MAXURACY CO.,LTD					
Drawn BY	Woo10e	Project	MULTI PAD	Rev	0.1
Checked BY		Title	7Inch SUB LCD(Hallsensor)	Size	A3
Approved BY		Date	Tuesday, April 15, 2008	Sheet	1 of 5

MAXURACY CO.,LTD					
	Drawn BY	Woo10e	Project	MULTI PAD	Rev	0.1
	Checked BY		Title	7Inch SUB LCD(Touch)	Size	А3
	Approved BY		Date	Tuesday, April 15, 2008	Sheet	2 of 5

History Document Number Rev <RevCode> Thursday, March 27, 2008 55

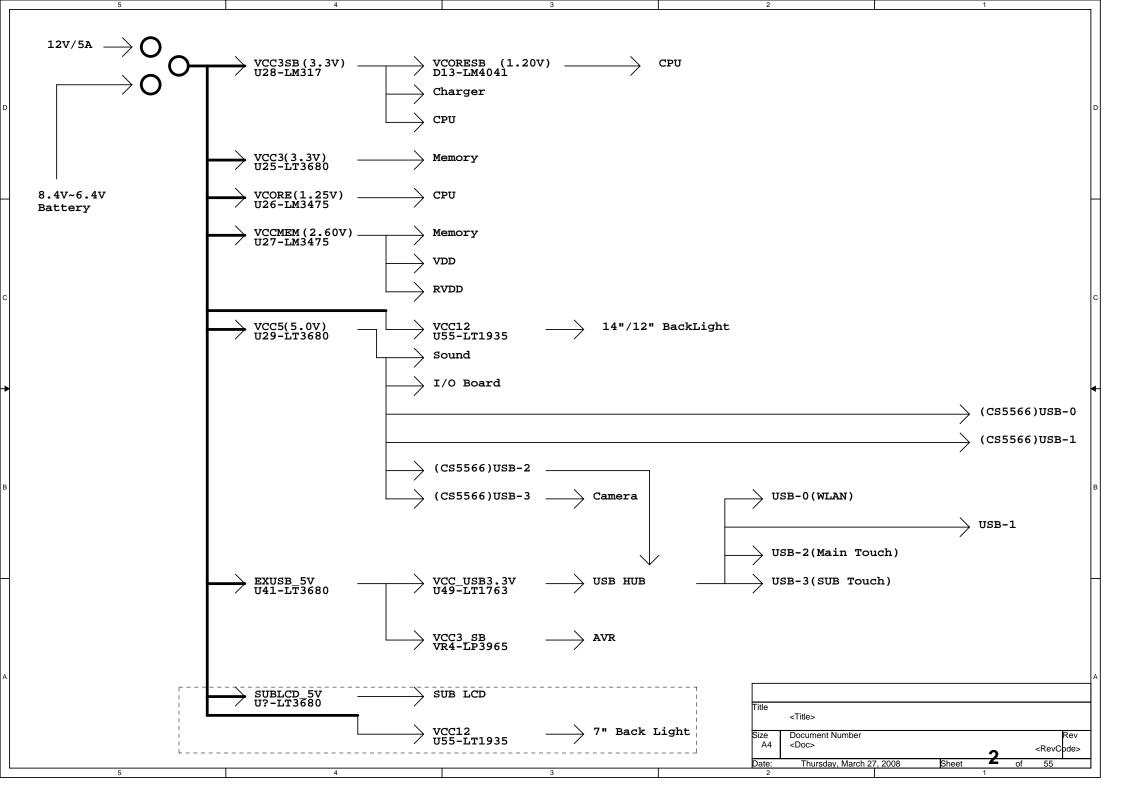
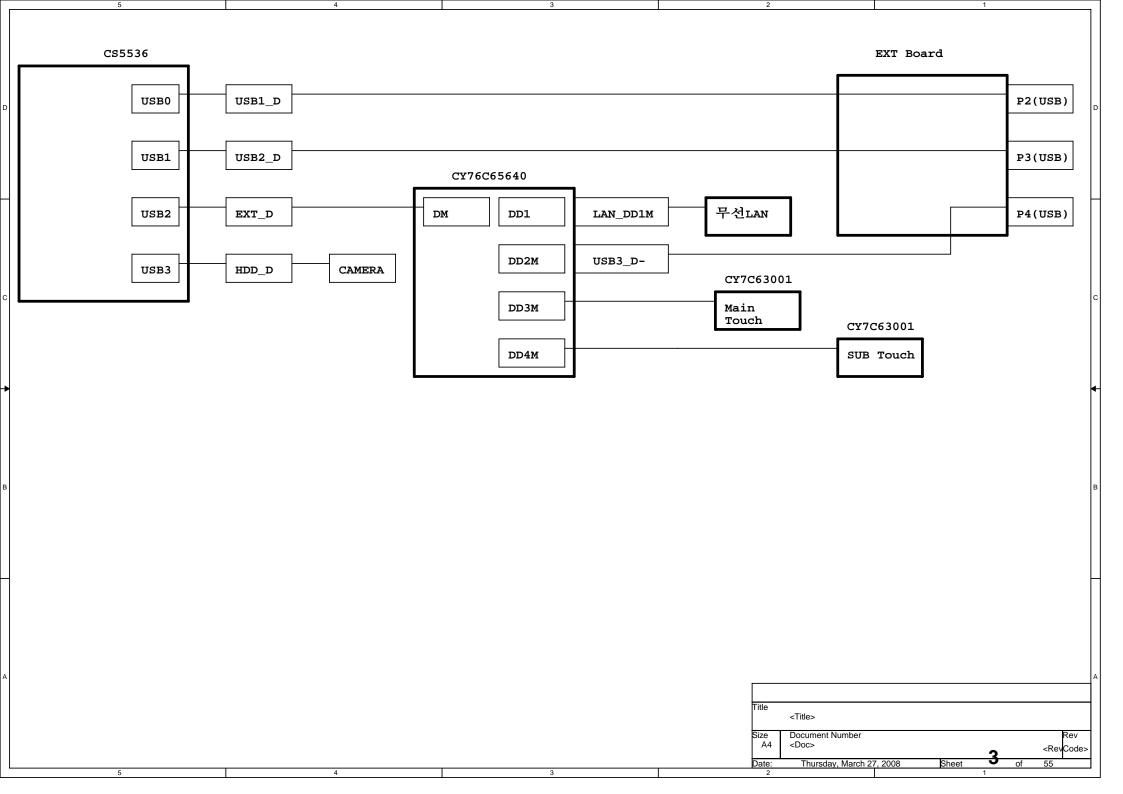
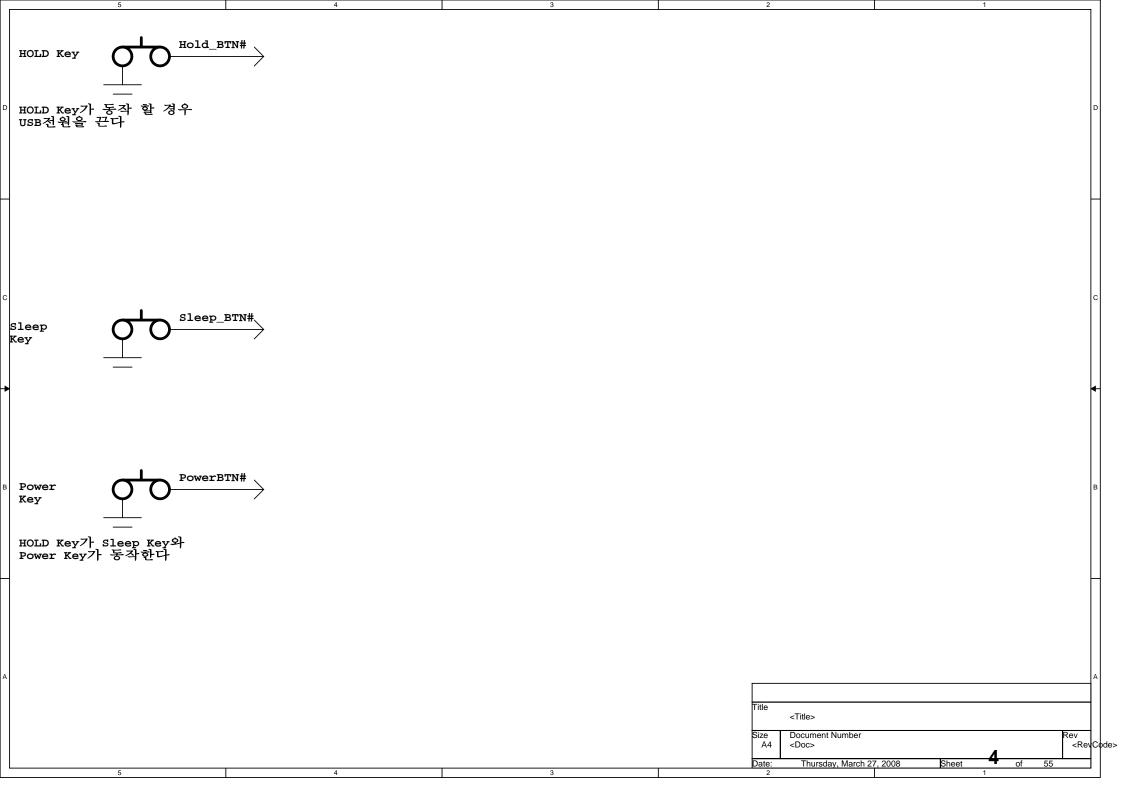
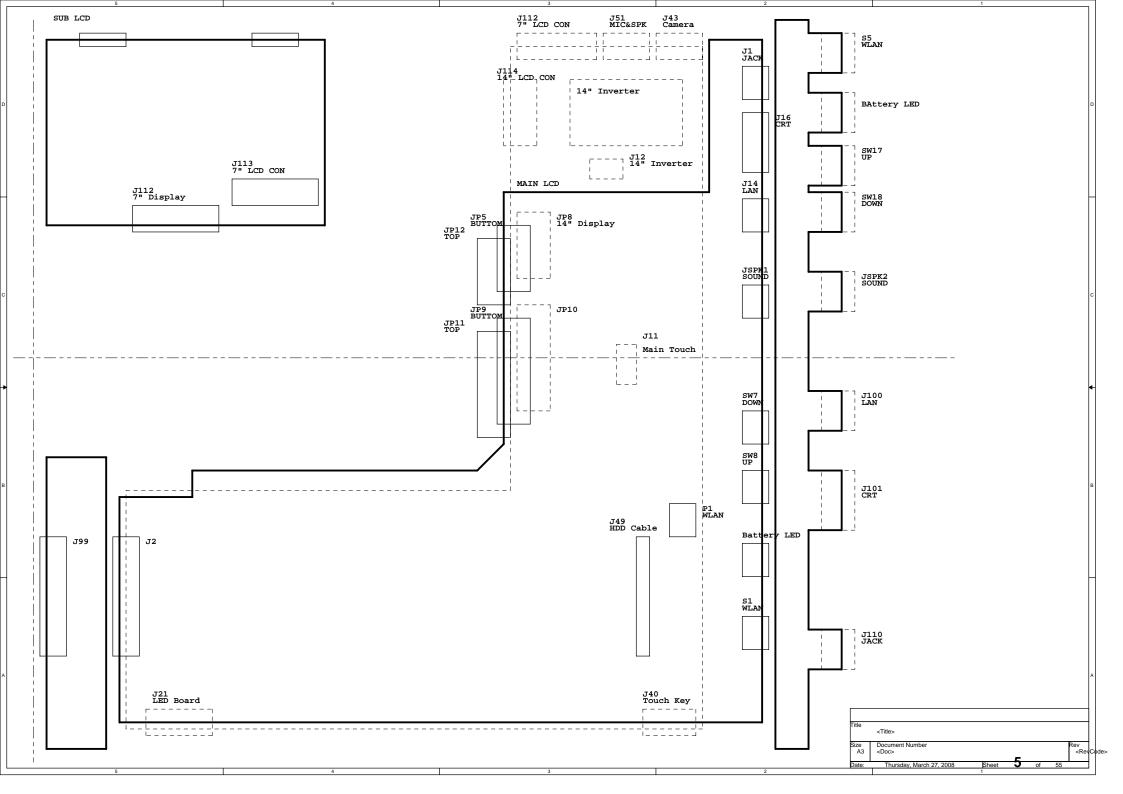
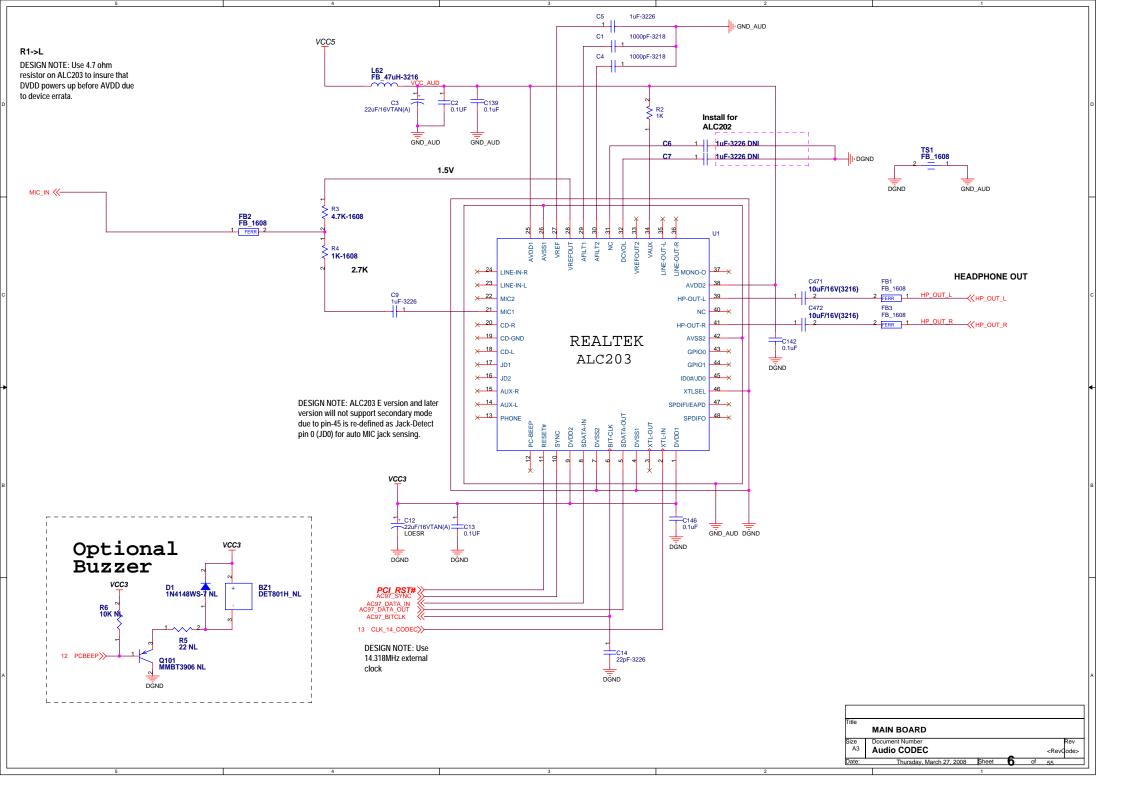
2007년 11월 10일 수정사항

PAGE3: 저항들 R20부터 R26 1608 SIZE로 변경. D5제거

PAGE5: R49추가 U9 PIN25번 VCC연결 PAGE10: ENP1#제거 후 VCC5연결

PAGE15: J49, PIN 40,41 GND제거 후 VCC5로 변경

PAGE18: U25,U29,U41 IC 변경 VR4 EXUSB_5V로 변경 R494제거. 모든 저항을 1608 SIZE로 변경

PAGE22: R275,R270을 10K를 1K 로 변경

PAGE 24: JP7에 11번을 GND 수정

PAGE26: J42에 1,2번을 VCC5를 EXUSB_5V로 변경 C363,364 VCC5를 EXUSB_5V로 변경 PAGE28: U51에 4번핀 ENP1# 한개를 삭제

2007년 9월 12일 수정사항

R25 32.4K ==> 18K 온도 센서 제어

R26 309K ==> 510K 충전 시간 제어

Q10 Del. ==> Charge LED 제어

R42 Del. ==> Charge LED 제어

U4 Del. ==> Camera USB Mux 제거

R44 Del. ==> Camera USB Mux 제거

0105 Del. ==> Camera 전위 관리

R458 Del. ==> Camera 전원 관리

Q106 Del. ==> WLAN 전원 관리

R459 Del. ==> WLAN 전원 관리

U25,U29 Pin7 Open J12 삭제, LCD BackLight Inverter EXT Board 아래로 이동

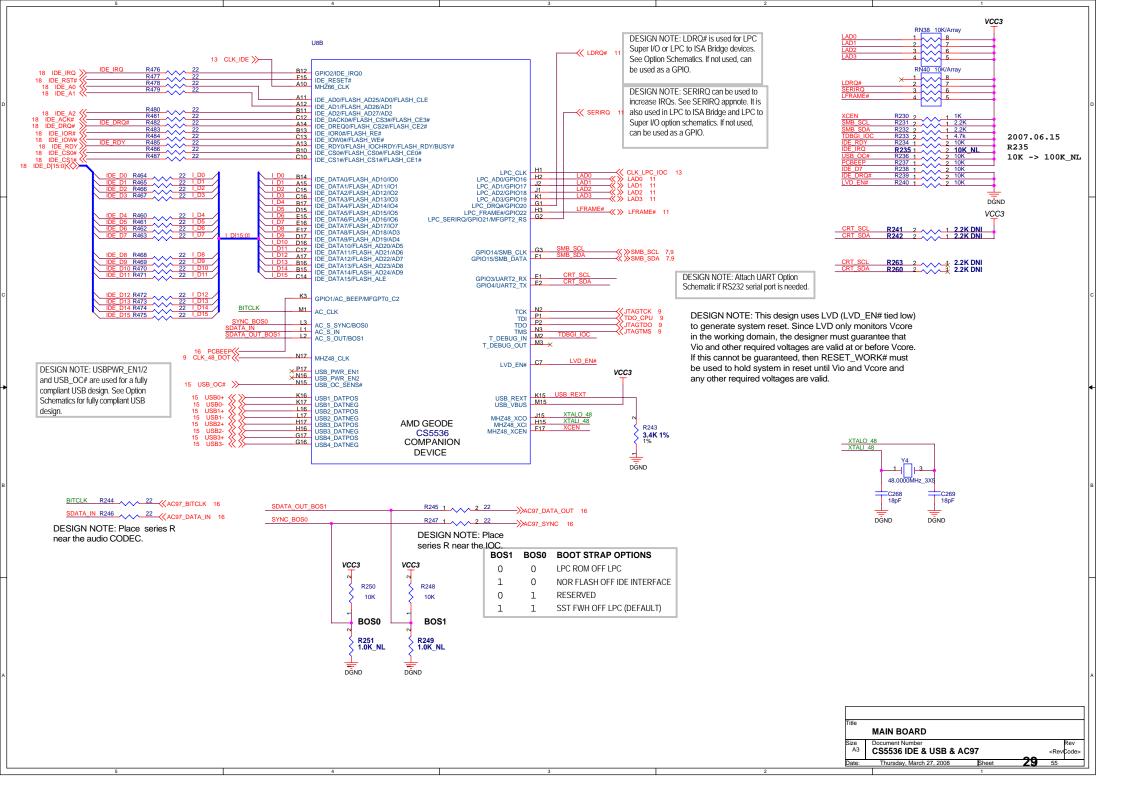
2007.06.15 R253, R254, R255, R257, R259 4.7K -> 4.7K_NL

<th>R295 A A 4.7K</th> <th></th>	R295 A A 4.7K	
M_D31	**		2007.06.15
M_D30	<< <u>M_D30</u>	R296 4.7K	🕇 R297, R298, R299, R304
M_D23	<td>R297 4.7K DNI OPEN</td> <td>4.7K -> 4.7K_NL</td>	R297 4.7K DNI OPEN	4.7K -> 4.7K_NL
M_D7	//M_D7	R298 4.7K DNI OPEN	_
M_D6	//M_D6	R299 4.7K DNI_OPEN	_
M D3	((<u>M_D3</u>	R300 4.7K	
_	//M_D2	R305 A A 4.7K	
M_D2	11	1,505	†
M_D0	<u M_D0	R304 4.7K DNI OPEN	→
M D32	//M_D32	R301 4.7K	
_	//M_D26	R303 A A 4.7K	
M_D26	11		₹
M_D20	M_D20</td <td>R302 4.7K</td> <td>→</td>	R302 4.7K	→
			<u></u>
		,	_ DĞND
			DGND

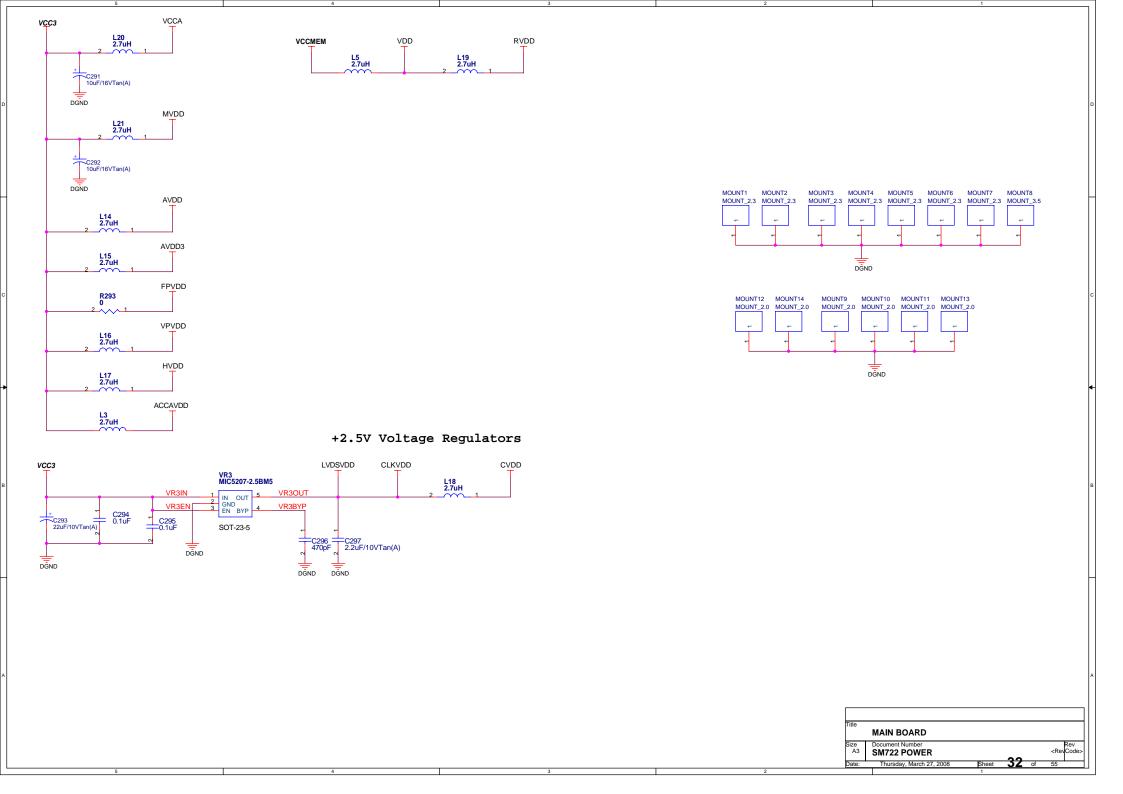
2008년 3월 4일 JP9 Pin번호 수정함 LVDS Transmitter 40Pin으로 수정요망 Transmitter Strobe Setting: VDD 3.3V없음->VCC3으로교체 R121=10k, Rising Edge Strobe R121=OPEN, Falling Edge Strobe 7" Display 22 0603 VCC3 VCC3SB TXON>> —>>>7"_TxOUT0-R318 200 0603 JP9 ACT80-31100 R319 22 0603 —>>>7"_TxOUT0+ TXOP>> >7"_UP
>SLEEP_LED
>HOLD_BTN#
>BEAM_LED
>HDD_LED TOUCH2_PWR 40 39 38 37 36 35 34 33 SGND->DGND 로 교체 R320 22 0603 7"_TxOUT1-TX1N> -->>7"_TxOUT1-R321 200 0603 32 31 30 29 28 27 26 25 24 23 22 21 AUDIO_R-R322 22 0603 7"_TxOUT1+ —>>>7"_TxOUT1+ CAMERA_PWR CAMERA_D-CAMERA_D+ TX1P>> DV_SW
CAMERA_SW
BEAM_SW R323 22 0603 7"_TxOUT2-TX2N> →>>7"_TxOUT2-R324 200 0603 R325 22 0603 7"_TxOUT2+ DGND —>>>7"_TxOUT2+ TX2P>> DGNDGND_AUD R326 22 0603 7" TxOUT3-TX3N>> R327 200 0603 R329 22 0603 7" TxOUT3+ TX3P> 22 0603 R331 7"_TxCLKOUT TXCLKN R333 200 0603 ->>7" TxCLKOUT-R335 22 0603 7" TxCLKOUT+ ->>7"_TxCLKOUT+ TXCLKP Only install if no Load it If no U7 Loaded termination on the for Lynx3DM+ LVDS penal side VCC5 R328 0 D FPVDDEN(-G S R393 Q23 2N7002S SOT-23 VBIASEN<<-14"_BL_OFF# >>> 14"_BL_OFF# R332 4.7K R334 10K 2007-11-18, R165 삭제 2007-11-18, R161 삭제 2007-11-18, R164 삭제 DĞND 2007-11-18, L37 삭제 MAIN BOARD 2007-11-18, L36 삭제 Document Number Size A3 SM722 LVDS Thursday, March 27, 2008
